# SUBMISSION to DPIE

PROJECT: 200 ALDINGTON ROAD INDUSTRIAL  
ESTATE

15 December 2020

**RE: 200 ALDINGTON ROAD INDUSTRIAL ESTATE – TRANSPORT REVIEW  
CAPITOL HILL INDUSTRIAL ESTATE SUBMISSION**

**Figure 3 General Layout of 200 Aldington Road Industrial Estate**

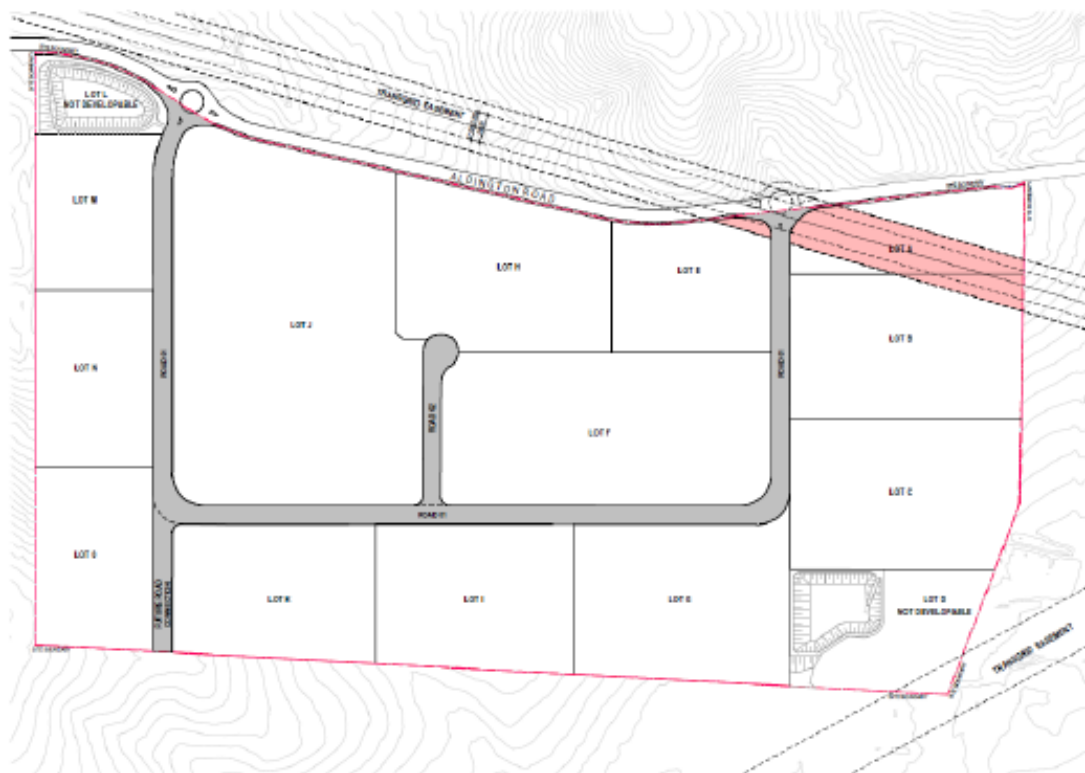
The layout shows that the development intends to provide only one point of access through the estate to Aldington Road. The singular connection is proposed through 'Estate Road 01' which is located at the southern end of the site. This entry point is marked with a red circle in Figure 3.

This subdivision layout is inconsistent with the Mamre Road Precinct planning policies and is therefore strongly opposed. This is because the subdivision layout is inconsistent with the Structure Plan and the Road network plan as it does not indicate a northern end access point through the subdivision. Further, the 200 ARIE has not considered the potential staging of the Seraglio Estate development to the east.

The Mamre Road Structure Plan and the draft DCP road network clearly show a road connection point at the northern end of the Stockland / Fife land.

The Seraglio Estate intends to develop in two stages. Stage 1 consists of the development of the northern portion of the estate. This misalignment with the Mamre Road Precinct planning policies subsequently results in the land locking of the Seraglio Estate stage 1 development. The subdivision is therefore counterproductive to the development of the Seraglio Estate and the Mamre Road Precinct.

1. The Department require 200 ARIE to amend their proposal to include the three connection points as shown in the Draft DCP.
2. 200 ARIE should provide a logical subdivision plan that is cognisant of road access requirements for development in the east.

**Figure 4 Stage 1 works of 200 Aldington Road Industrial Estate development**

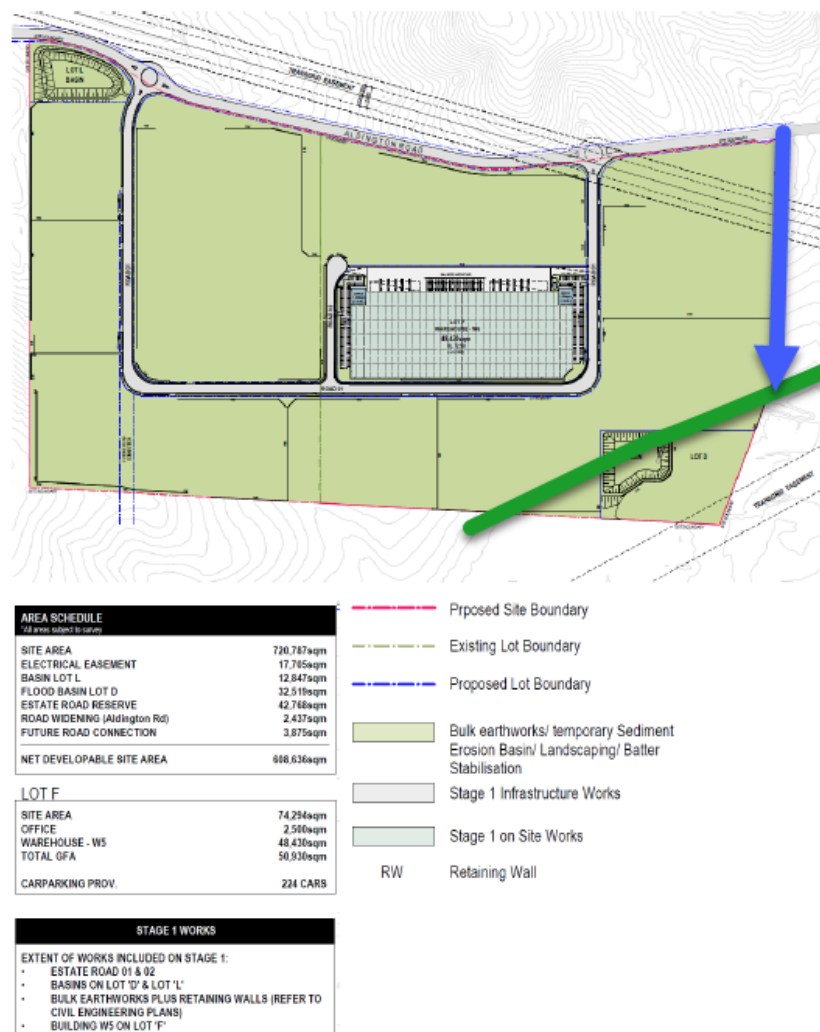
It is noted that the proposed staging works of the 200 ARIE do not include an initial connection through the estate to Aldington Road as part of stage 1.

**Figure 4.** Stage 1 infrastructure works involves the construction of the road infrastructure and internal access roads of 'Estate Road 01' and 'Estate Road 02' as referred to in the EIS. It is understood that the summary of the Stage 1 works provides an indicative future connection to the Seraglio Estate. 'Estate Road 01' is marked with the red circle.

It is noted, however, that no indication has been made to a north end connection between the estates and 'Estate Road 01'

It is essential that a condition of consent for the 200 ARIE development is that the connections to the Seraglio land be capable of construction as part of the first stage of the development.

1. That provision be made for the northern access point (Open Space Edge Road).
2. A condition of consent be included to ensure that the Seraglio connections are part of the Stage 1 development process to prevent the land being landlocked for an undetermined period of time.

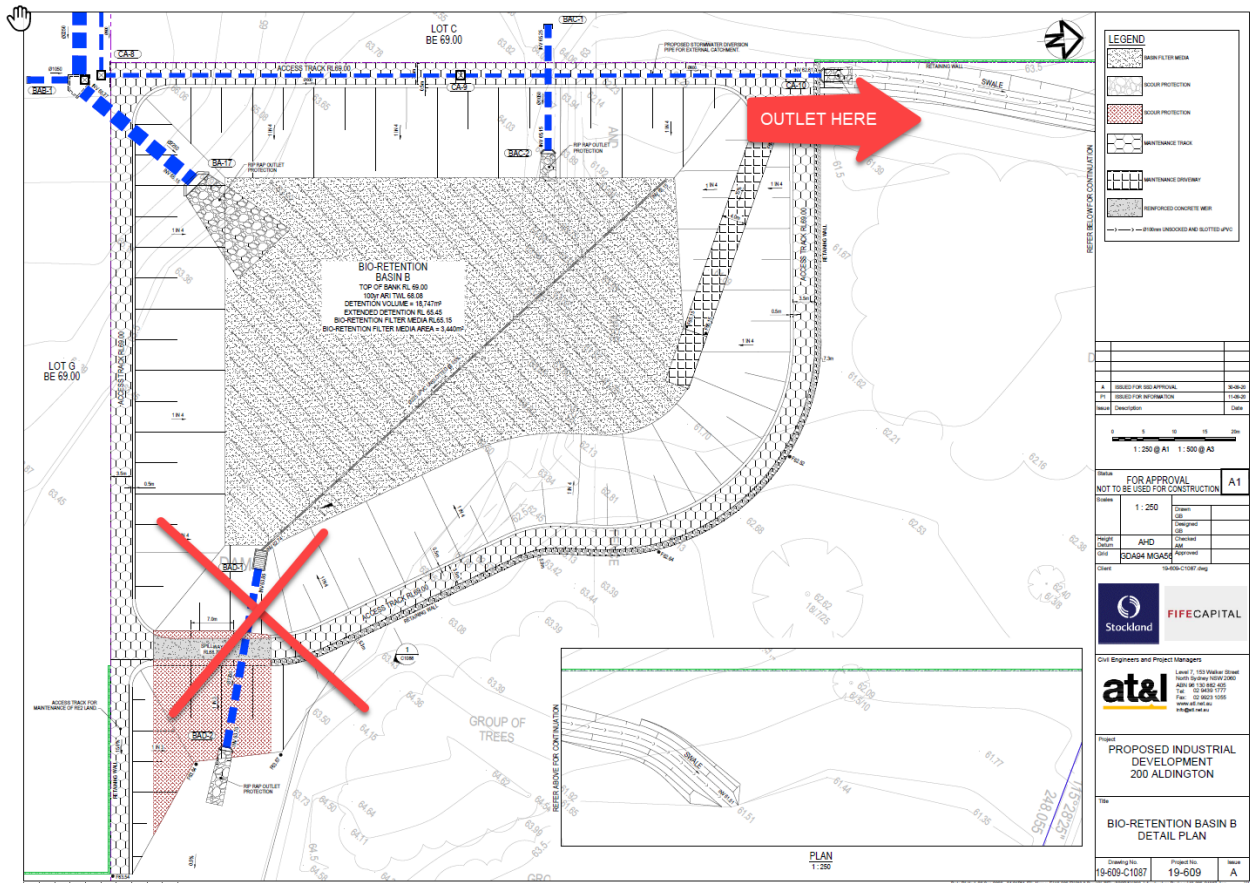
The assertions of Appendix R Part 5 and Appendix S of the EIS that the unnamed tributary of Ropes Creek does not proceed to the north are rejected. The original watercourse has elevated the access road and blocked the flows of from proceeding directly downstream to the north on its historic and traditional route. The flows to

north-east to Ropes Creek through the Seraglio land only occur because of the overflow from the constructed dam, not as the original stream flow. Accordingly, the proposed diversion of the stormwater from 200 ARIE onto our site must be rejected. The Seraglio letter attached includes some details of the history of this matter.

Specifically, even if the Department does not require the basin to be relocated out of the floodplain as recommended below, then the basin outlet as shown in Appendix F of the EIS must be relocated as shown in the image below.

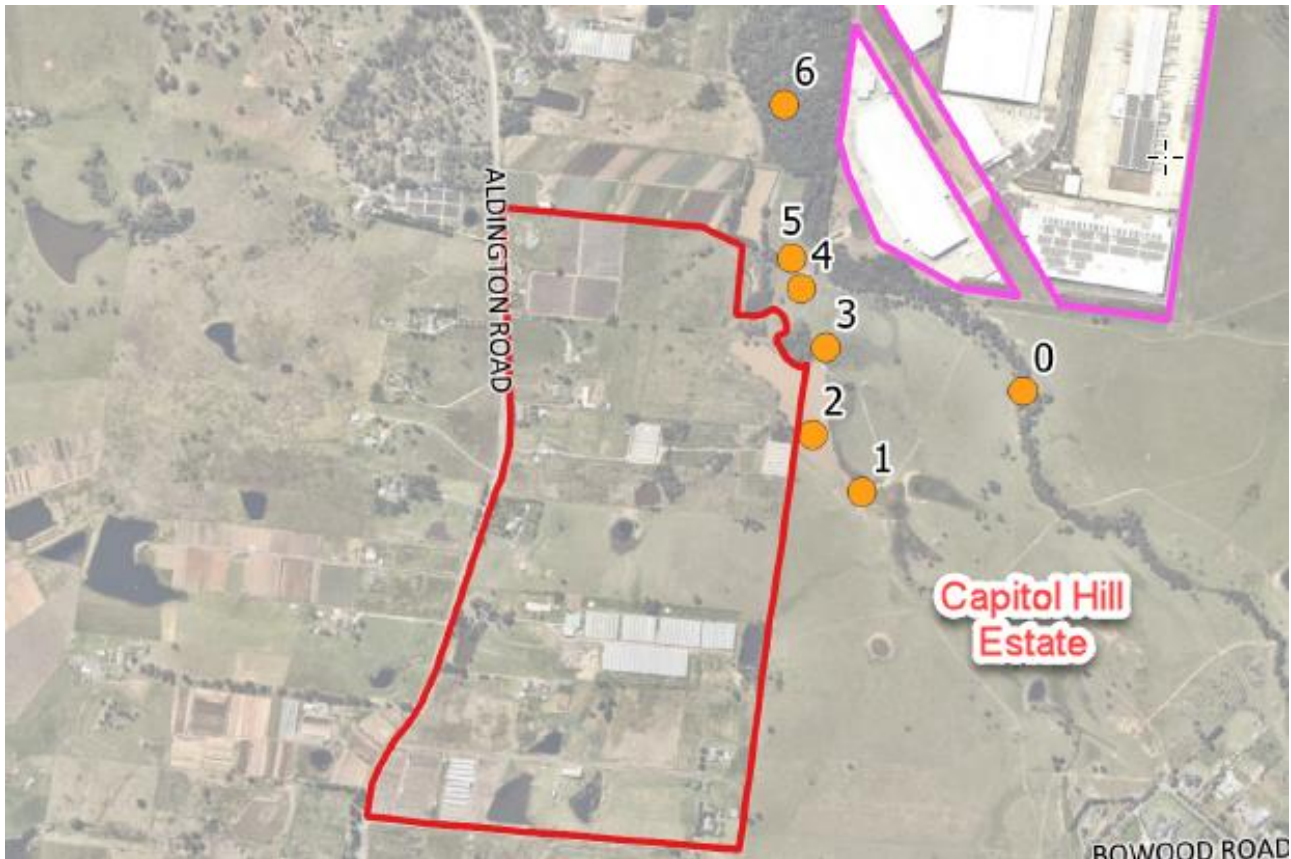
The EIS does not explicitly state the full extent of the flooding impacts on the Seraglio land caused by the filling of the floodplain and flowpath of Ropes Creek and its tributary. Appendix F of the EIS indicates that the significant encroachment into the floodplain by the development, particularly with the construction of Lot G, but also Lot C (to a lesser degree).

The EIS Appendix Q and R seem to indicate that the development does have an impact downstream of the development on Ropes Creek, but they also indicate that the proposed development does have at least an 80mm impact upstream of 200 ARIE (i.e. within our site). This is totally unacceptable and contrary to the provisions of the DCP. To be clear, this outcome is entirely unacceptable, and we will pursue every avenue (legal if necessary) to protect our rights to prevent 200 ARIE from increasing the flooding on our site.

1. That the Department require 200 ARIE to adjust their application to ensure no impact on the upstream flood levels.

**Figure 2: Indicative Concept Master Plan for SSD-10479**

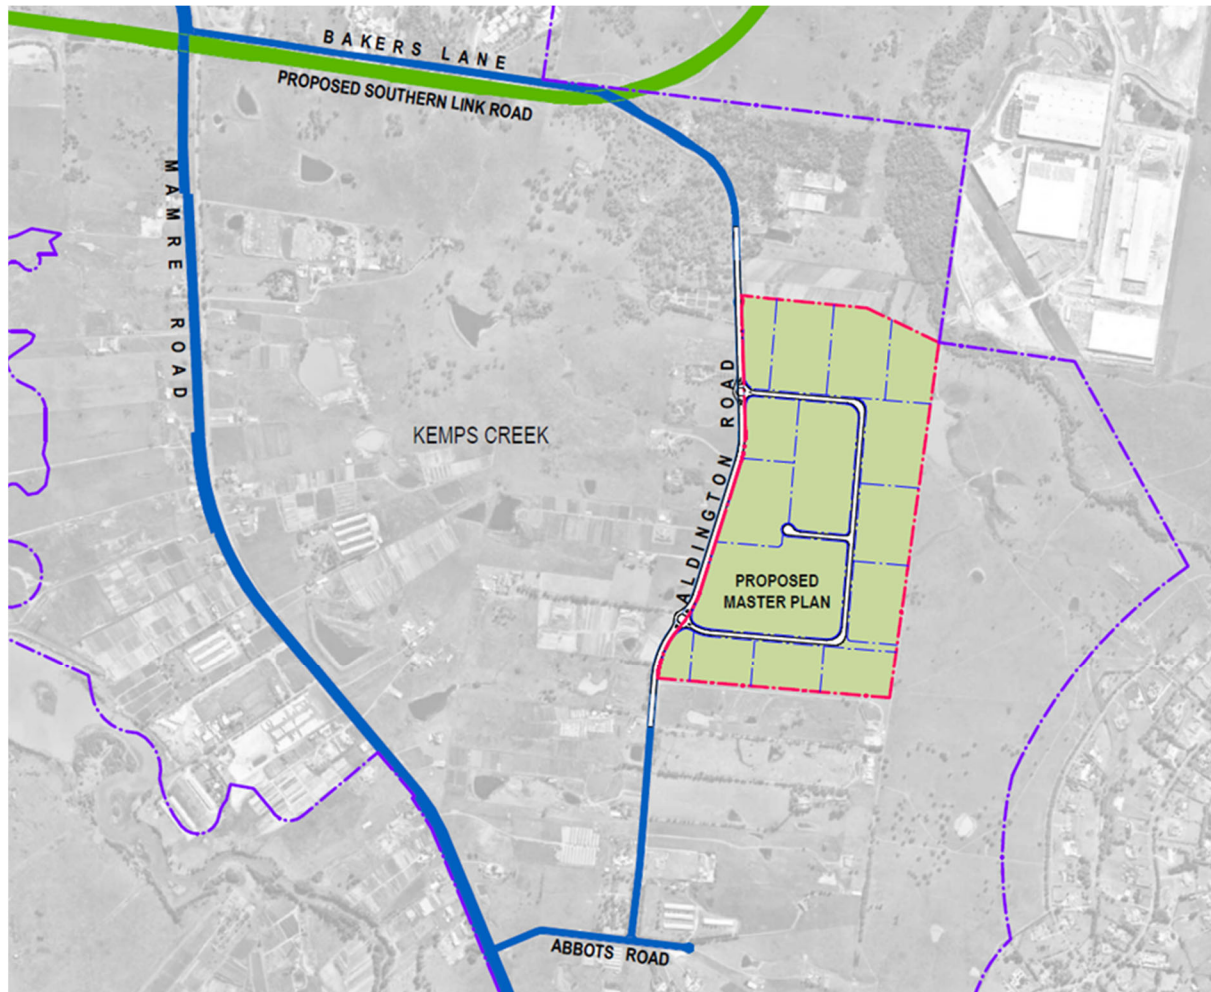
The proposed road network for the SSD-10479 (refer to Figure 2) is not consistent with Figure 14 -Precinct road network and hierarchy map in the Draft MRP DCP (refer to Figure 3).

However, the proposed road plan for the SSD (refer to **Error! Reference source not found.**) only provides **one road connection** to the Capitol Hill site, which will be disadvantaged by the lack of road connections.

A loop road (i.e. Road 01) is proposed on the Concept Plan, which is inconsistent with the Draft MRP DCP. Road 01 has 22.6m road reserve.

On that basis, the proposed road network for the SSD should be modified to reflect the precinct road network as per Figure 14 of the Draft MRP DCP, in particular:

- Southern 'High Order Road' to extend to the eastern site boundary, providing a frontage road with Lot O
- Northern 'High Order Road' to align with the northern site boundary
- 'Open Space Edge Road' to be included in the Concept Plan.

The proposed east-west Higher Order Roads should be amended to have a road reserve width of 26.4m instead of 22.6m, to be consistent with the Draft MRP DCP.

**Figure 4: Master Plan for SSD-10479**

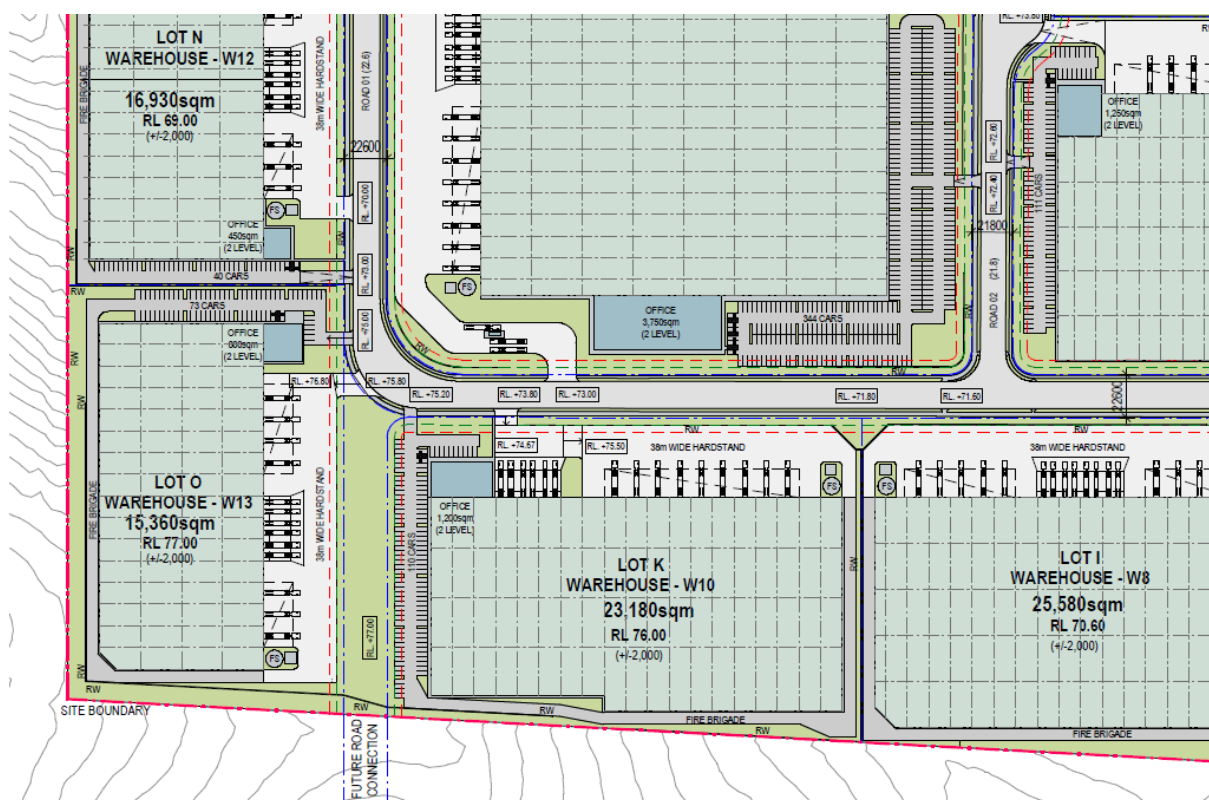
It is noted that the following driveways are located within the prohibited locations:

- Lot O – car park access
- Lot O – loading dock access
- Lot K – car park access.

Whilst the location of car park and loading dock access can be determined as part of subsequent development applications, Figure 4 shows that Lot O has a limited frontage road length, which make it difficult to achieve compliant driveways for the car park and the loading dock access. Therefore, as specified previously, the proposed road network for the Concept Masterplan should be modified to include the southern 'High Order Road' to extend to the eastern site boundary, providing a frontage road to Lot O.

1. That the proposed access arrangements to Lot O and K be adjusted, by relocating them, or extending road construction, to enable the future road to comply with the relevant AS.
